**MILTON MUNICIPAL UTILITY COMMISSION
CABELL COUNTY, WEST VIRGINIA**

CONTRACT #1 – MORRIS MEMORIAL SANITARY SEWER EXTENSION

ADDENDUM #2

FEBRUARY 10, 2022

SHEET No.
E-1

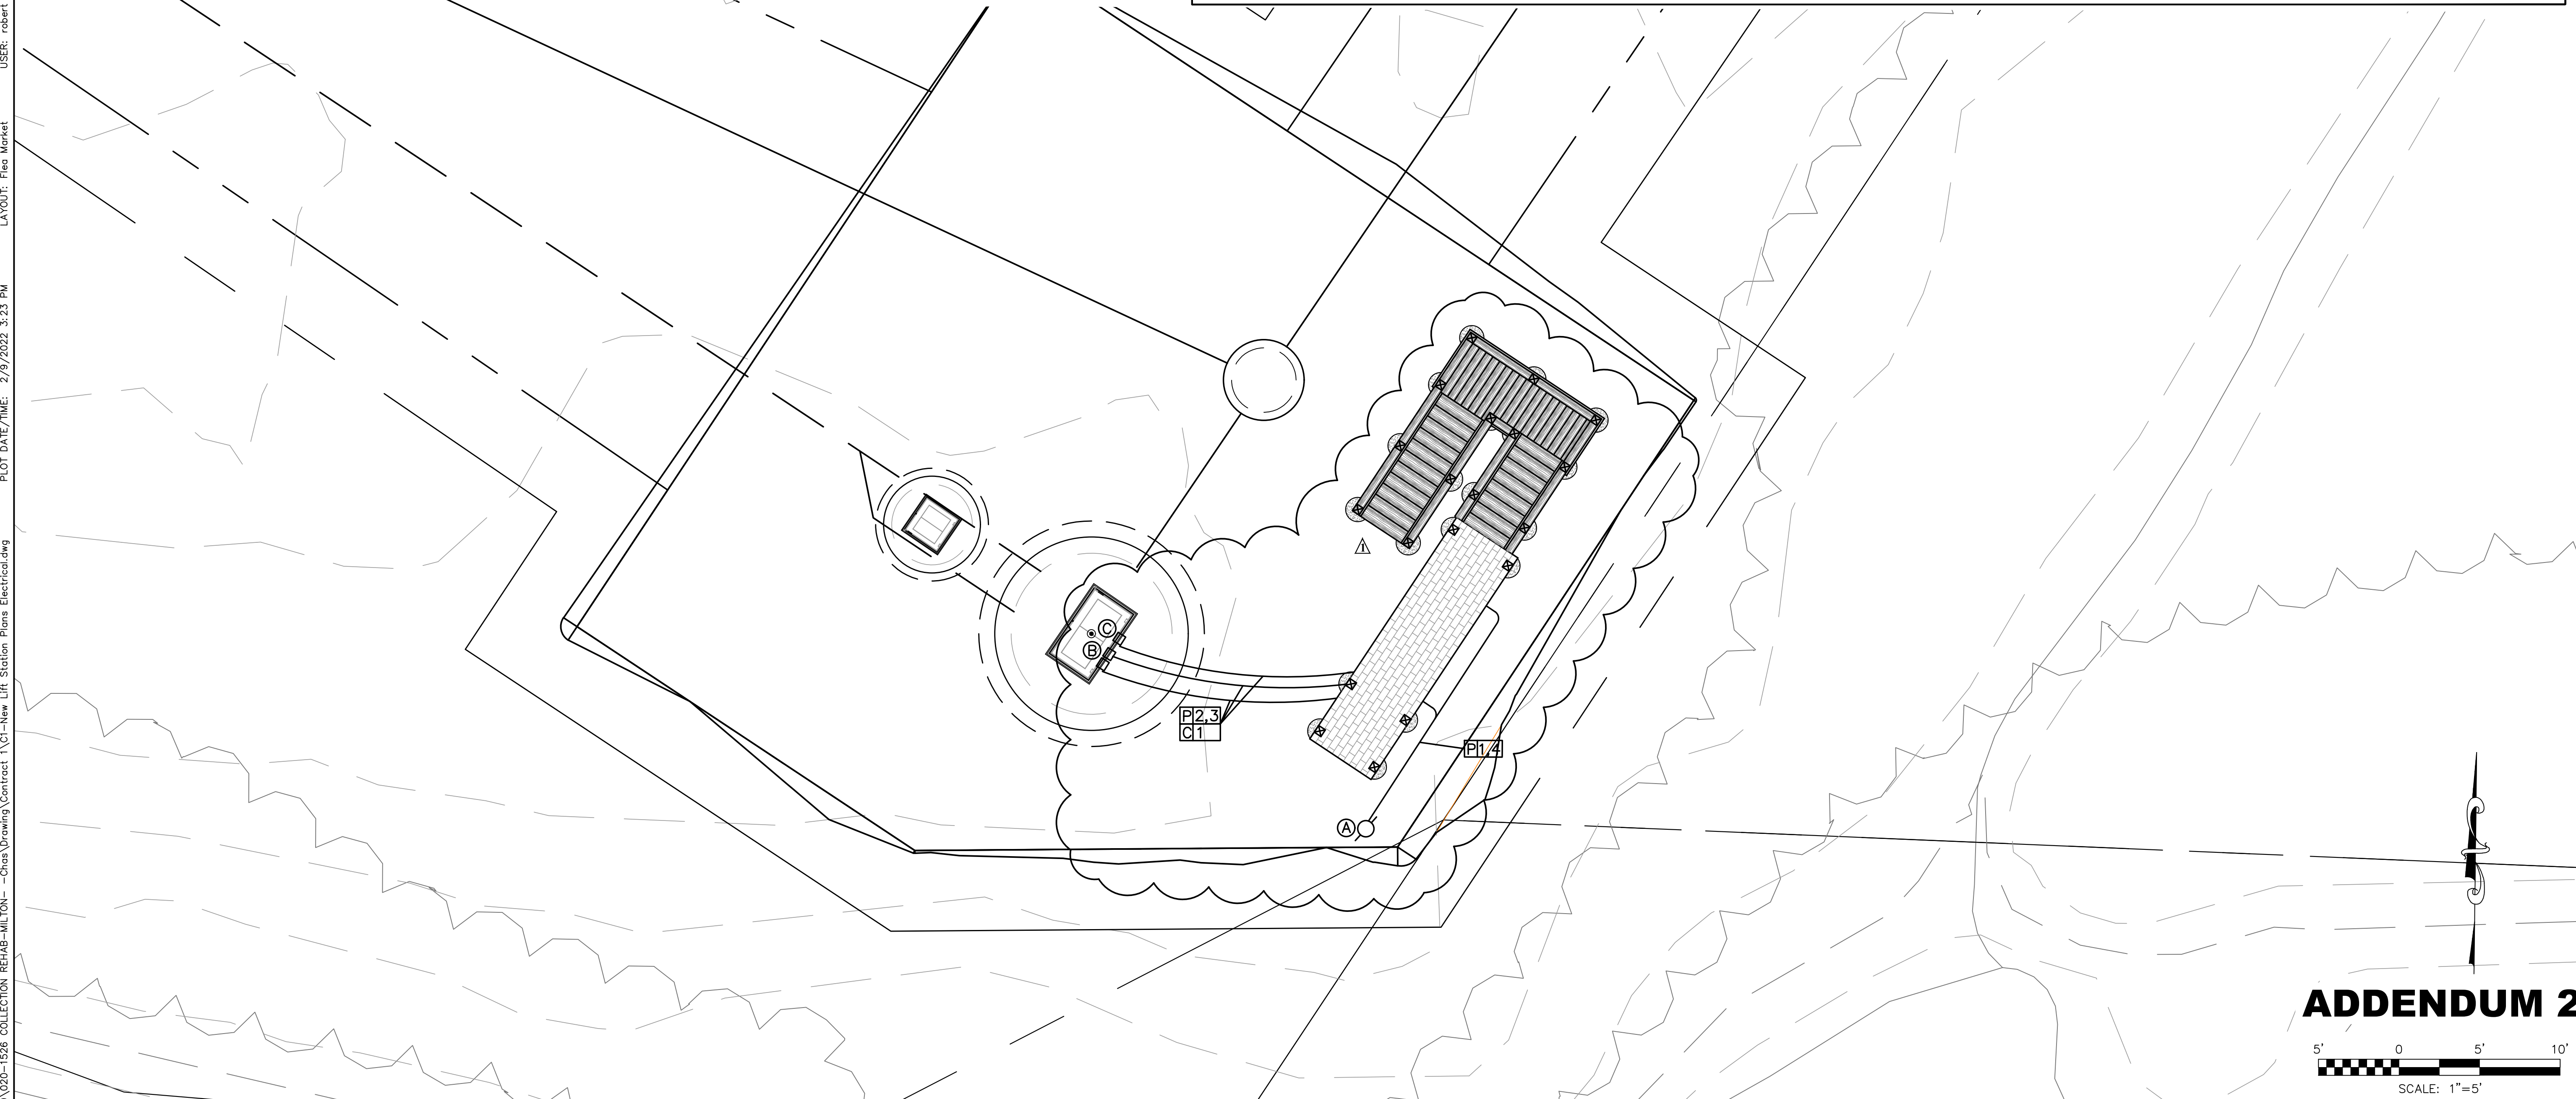
THE INFORMATION CONTAINED HEREIN IS THE SOLE PROPERTY OF THE THRASHER GROUP INC. REPRODUCTION OF THESE DOCUMENTS IN WHOLE OR IN PART, FOR ANY REASON WITHOUT PRIOR WRITTEN PERMISSION, IS STRICTLY PROHIBITED. COPYRIGHT © 2022 THE THRASHER GROUP INC.			
1	KMP	1/2022	ADDENDUM 1 - UPDATED LIFT STATION CHANGES PER SHEET LS-1
2	FD	2/2022	ADDENDUM 2 - UPDATED WIRE SIZE
NO.	BY	DATE	DESCRIPTION

SHEET No.
E-2

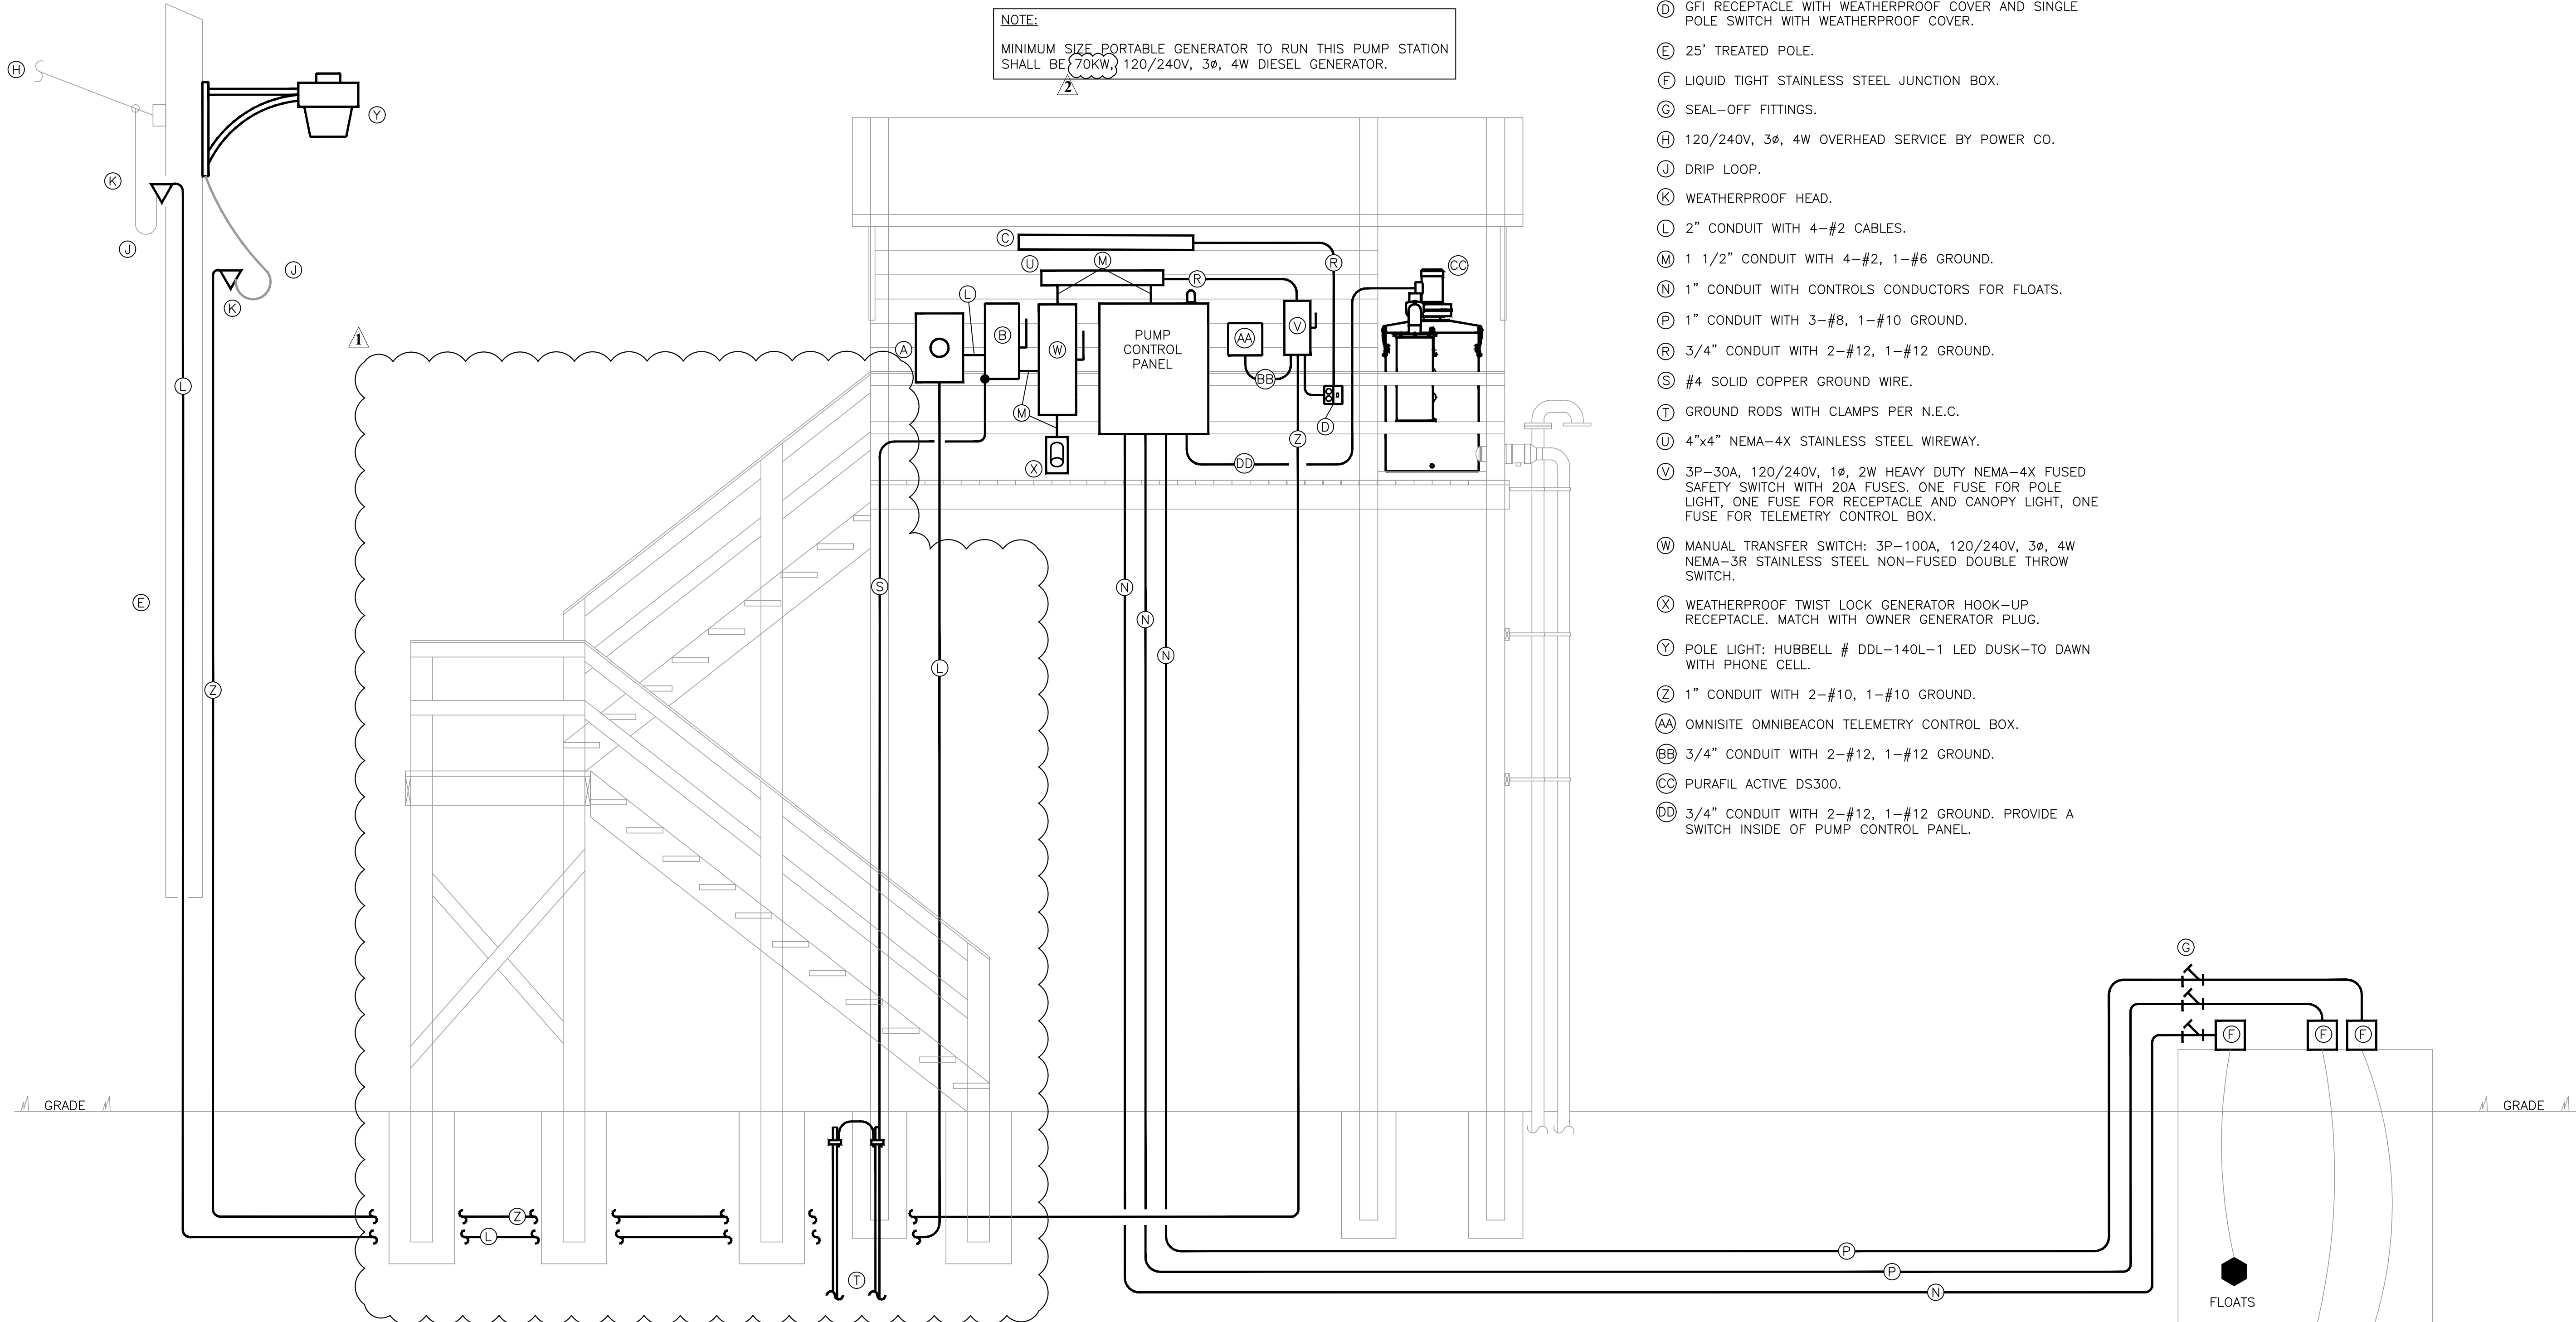
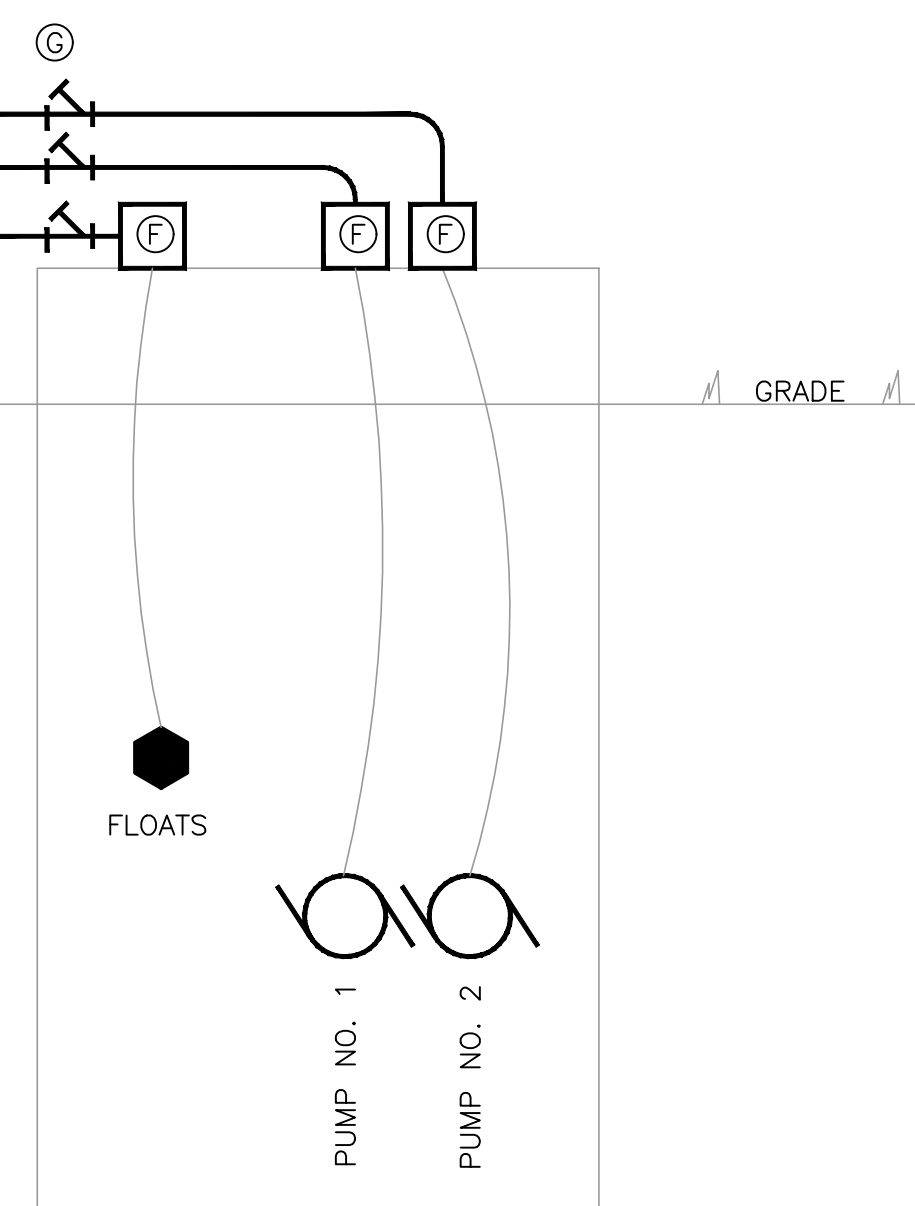
1	KMP	1/2022	ADDENDUM 1 - ADDED REVISED STAIR ACCESS
2	FD	2/2022	ADDENDUM 2 - GENERATOR SIZE
NO.	BY	DATE	DESCRIPTION
